# Access Compliance Report

## Public Rights-of-Way

Intersection ID: 43192	Main Street: GUM_BRANCH_RD	Cross Street: VALLEYDALE_RD	Location:	N
ADA ID: 38727178C416	Ramp Type: BlendTrans2	Initial Pass/Fail: Fail	Overall Compliance: No	Severity Score: 8.75

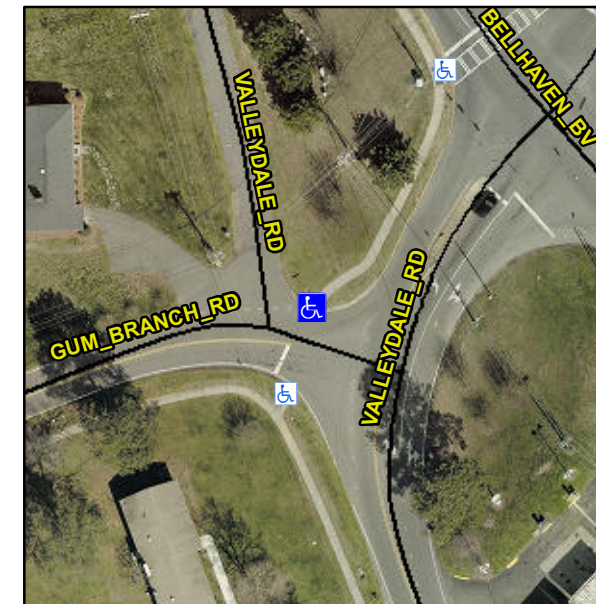
**Not Found, R304.5.1**

Compliance	Description	Data	Compliance	Description	Data
N/A	Ramp Length (in)	76.5	Yes	BlendTrans Slope (%)	3.2
No	Ramp Width (in)	47.0	Yes	BlendTrans XSlope (%)	1.6
N/A	Flare Type LT	N/A	N/A	Flare Type RT	N/A
N/A	Flare Slope LT (%)	N/A	N/A	Flare Slope RT (%)	N/A
N/A	Flare Traversable LT?	N/A	N/A	Flare Traversable RT?	N/A
N/A	Landing Length (in)	N/A	N/A	DWS Provided?	N/A
N/A	Landing Width (in)	N/A	N/A	DWS Contrast?	N/A
N/A	Landing Slope (%)	N/A	N/A	DWS Length (in)	N/A
N/A	Landing X Slope (%)	N/A	N/A	DWS Full Width?	N/A
N/A	Landing Curb? (Y/N)	N/A	N/A	DWS Offset (in)	N/A
N/A	Shared Landing?	N/A			
N/A	Gutter Ponding?	N/A	N/A	Gutter Slope (%)	N/A
N/A	Gutter Lip Ht (in)	N/A	N/A	Gutter X Slope (%)	N/A
N/A	Painted X Walk1?	No	N/A	Painted X Walk2?	N/A
	X Walk 1 Direction	To SW		X Walk 2 Direction	N/A
	X Walk 1 Width (in)	N/A		X Walk 2 Width (in)	N/A
	X Walk 1 Slope (%)	2.9		X Walk 2 Slope (%)	N/A
	X Walk 1 X Slope (%)	1.1		X Walk 2 X Slope (%)	N/A

N/A	Ramp inside XWalk1?	N/A	N/A	Ramp inside XWalk2?	N/A
	Road Slope (%)	1.1		Clear Space?	N/A
	Road X Slope (%)	2.9	N/A	Clear Space to XWalk (in)	N/A
N/A	Any Obstructions?	N/A	N/A	Storm Grate/Utility Hazard?	N/A
	Obstruction Type			Storm Grate/Utility Type	
		N/A			N/A
			Yes	Surface Condition? (G/P)	Good
			No	Curb Slope (%)	25.4

**Remove & Replace Curb Ramp With Two New Directional Ramps or Equivalent.**
